**WELDON VILLAGE MIXED USE** | YIELD STUDY

June 21, 2022  
 Job #22-RDU-030

Re: Dement Farms/ Weldon Village  
UDP Project No: 22-030

Below is a summary of the comments and response of the first review for the above referenced project

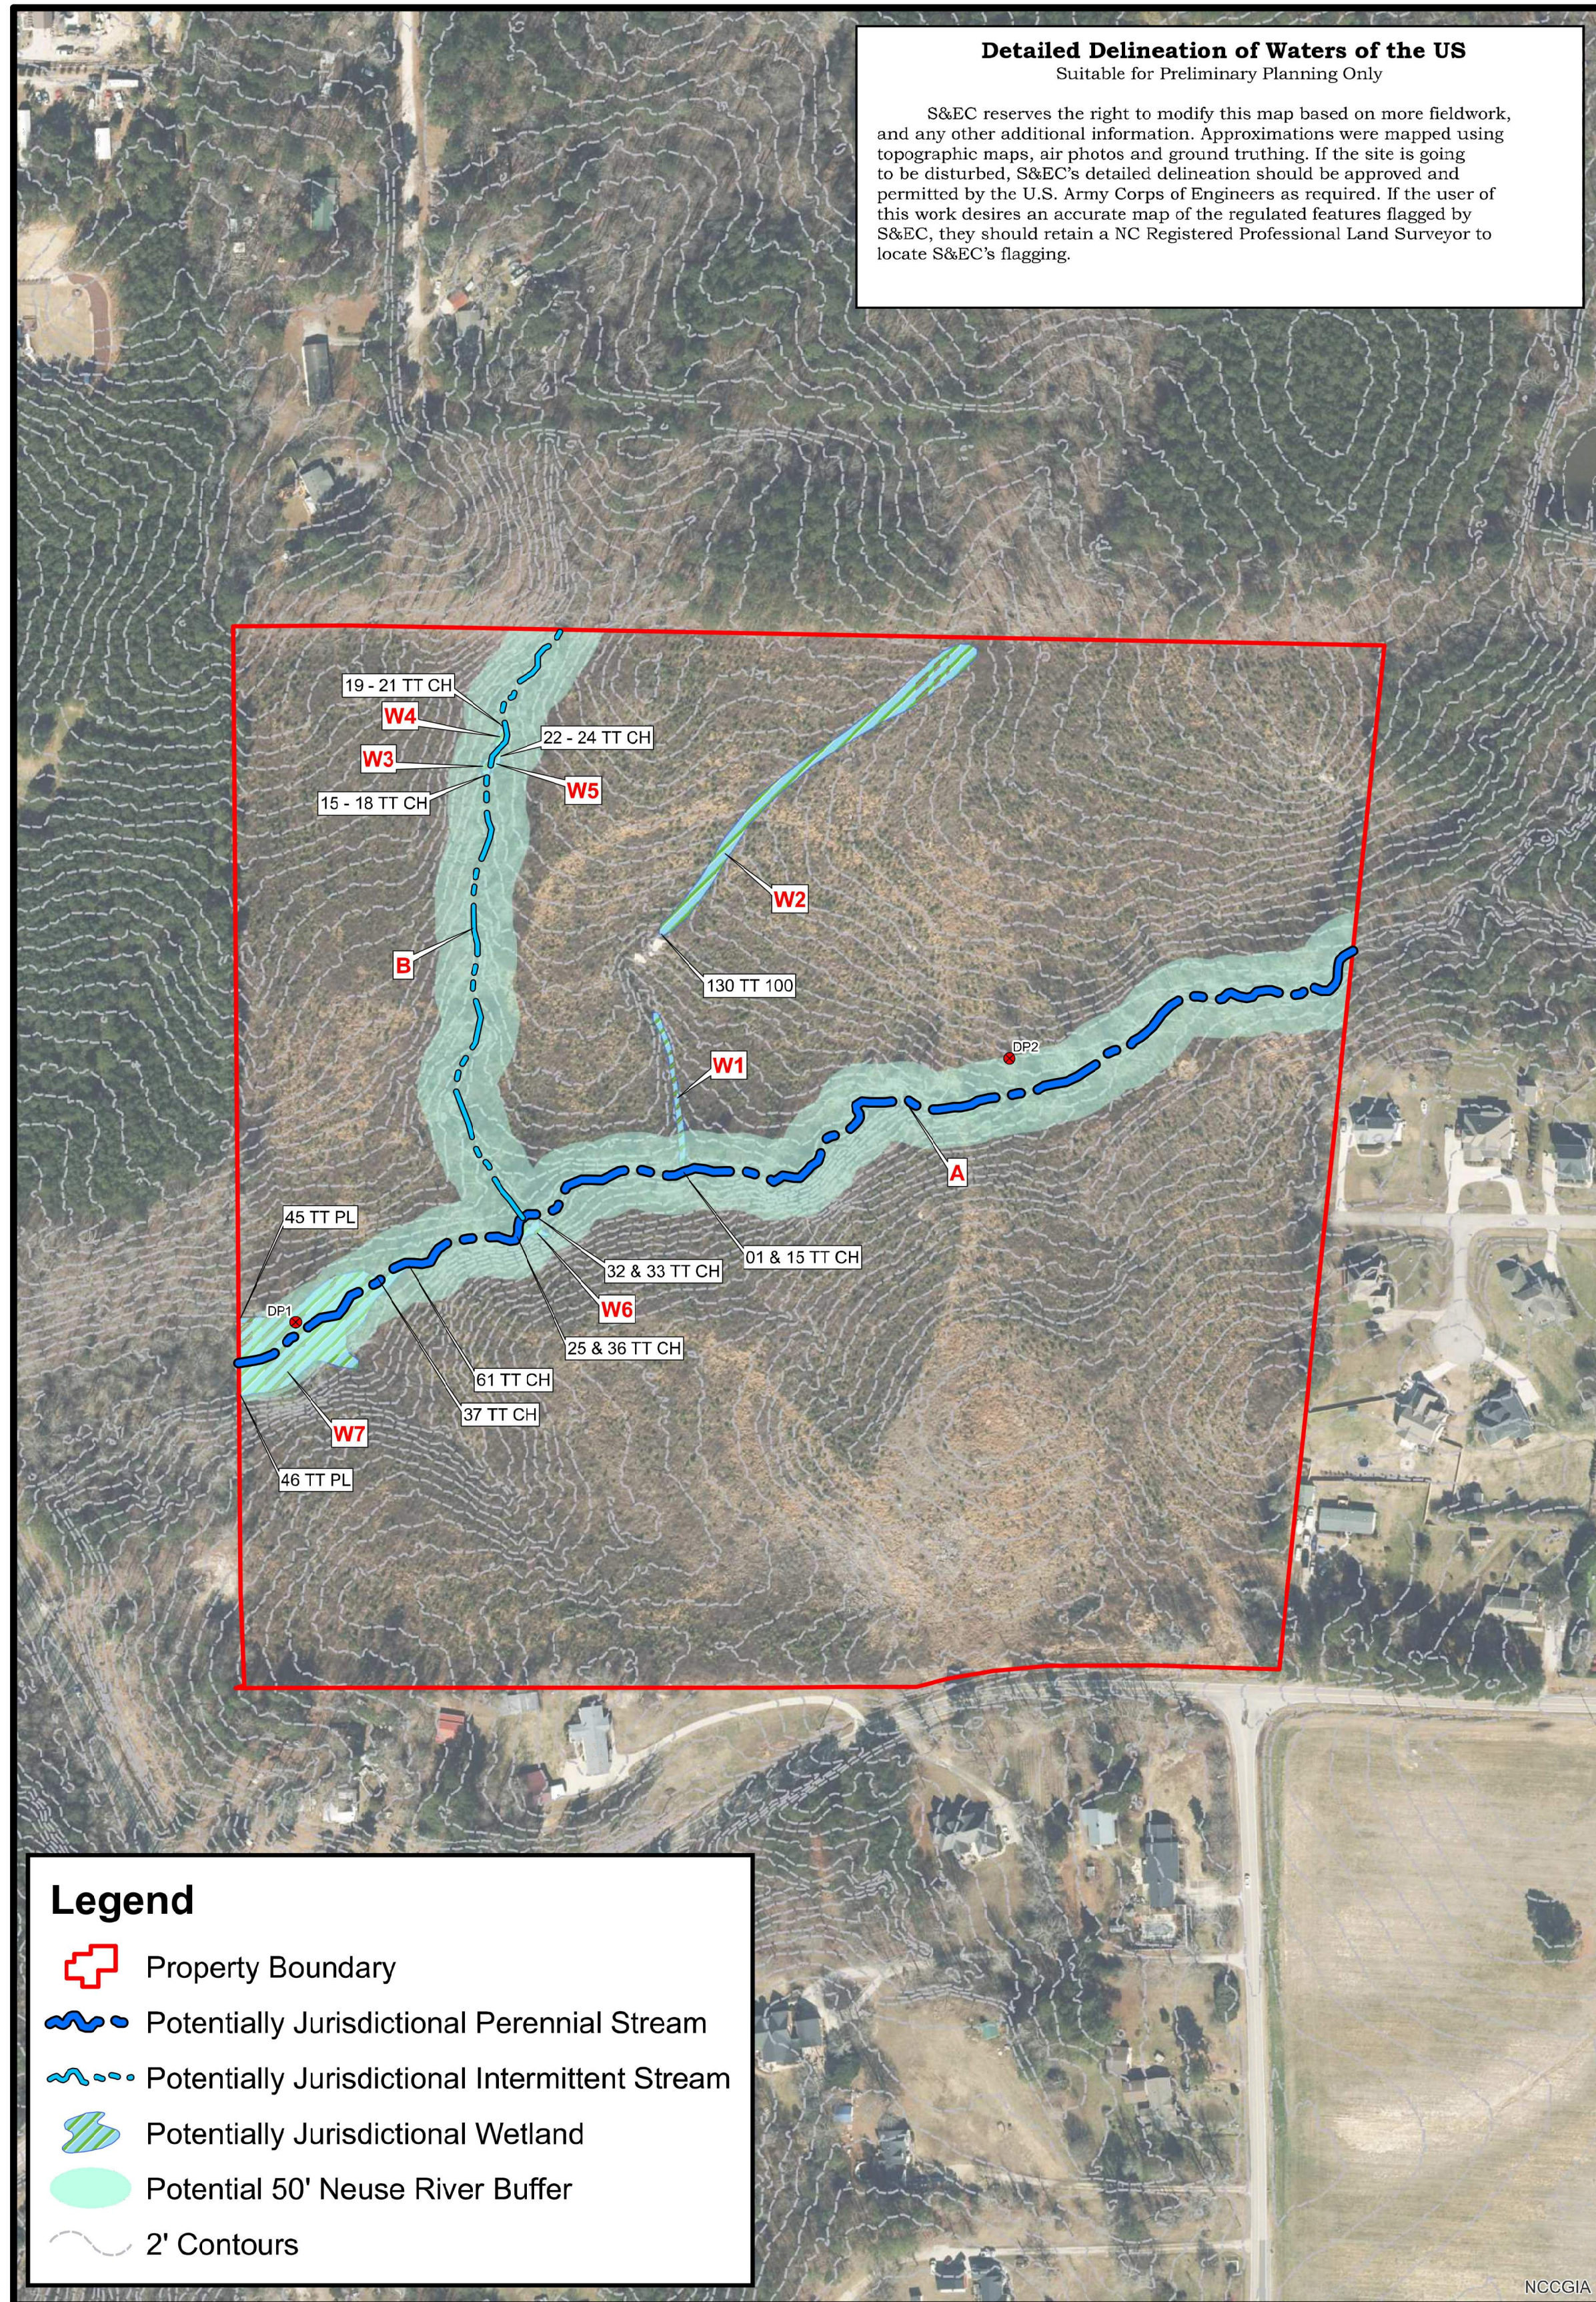
- The stub currently dead-ends in a back yard making the stub less likely to be realized. Shifting the stub further south is preferred.
  - The stub has shifted toward the south to avoid back yard conflict

- The Town's draft transportation plan calls for a continuous east-west roadway that connects Lucas Road to Horton Road. The current configuration precludes that concept.

- Crosswalk Included
- The greenway stub connects to a large lot in a cul-de-sac so would therefore never be continued. Recommend continuing the greenway along the east side of the roadway to connect to the James Allen LLC parcel / your northern property border instead.

- This stub dead-ends to large cul-de-sac lots and will likely never be utilized. Recommend removing it.
  - Stub has been removed.

- Road name, ROW width and SR number for adjacent roads.
  - Road names, ROW width and SR numbers have been provided
- Appears an SCM will be needed on this side of stream.
  - Stormwater from the lots west of the stream will be collected and sent to SCM on the eastern side of the stream
- Minimum intersection angle is 75 degrees. Shown as 66.29°. Revise as necessary.
  - Intersection angle is now 75°
- Can dead-end alley be avoided? Turn and extend alley to Avenue?
  - Alley is extended to Avenue
- Provide vicinity map.
  - Vicinity Map is provided
- Provide existing use of adjacent properties.
  - Existing use of adjacent properties is provided

- Please be sure that all residential setbacks can be met for these lots (Sec 6.5 & 6.6)
- Acknowledged
- Per Sec 11.3.E.5, cul-de-sacs are generally discouraged and are limited to 200'

- Cul-de-sac is 200'
- How will this open space be accessed?
- Open space will be accessed through cul-de-sac trail
- Per Sec 7.4.J & Sec 7.5.B, parking lot screening & landscaping required

- Acknowledged
- What uses will be permitted on this parcel (Sec 3.1.C)? How will this site be designed?
- Conceptual site design provided
- Please note that both passive and active recreational open spaces need amenities. Preserved natural areas or unimproved land cannot be counted towards the overall open space requirements from Sec 11.2.C. Open space menu from Sec 11.2.C.7 should be utilized

- Acknowledged
- How will this development meet the requirements of the distribution of uses table?
- Mixed Use – 100%
- What are the dimensions of the townhome lots? Per Sec 3.4, residential rear-loaded lots must be a minimum of 30' wide

- Proposed mixed use development will split WAP between two separate land uses: Single Use Retail and Major Subdivision.
- A Transportation Impact Analysis is required per Sec 11.3.D
- Acknowledged
- UDO Sec 3.4 requires all front-loaded lots to be a minimum of 80' wide. Council has approved single-family front-loaded lots at 60' wide as a minimum, 50' would be well below what they are comfortable with.
- All single family front loaded lots have changed to 60' wide
- This is only awarded when cul-de-sac is connected to other streets with greenway trails
- Acknowledged, points were deducted

- Could not locate the draft CTP. A town-maintained collector is proposed in the Knightdale Street Network Plan.
- Include a crosswalk for the greenway

- Greenway has changed alignments, and now runs along the east side of the roadway up to the northern boundary
- Recommend aligning this stub to be part of the continuous east-west roadway concept in the draft CTP that would connect Lucas Rd and Horton Rd

- Couldn't locate the draft CTP. A town-maintained collector is proposed in the Knightdale Street Network Plan. The stub is aligned to this collector road.
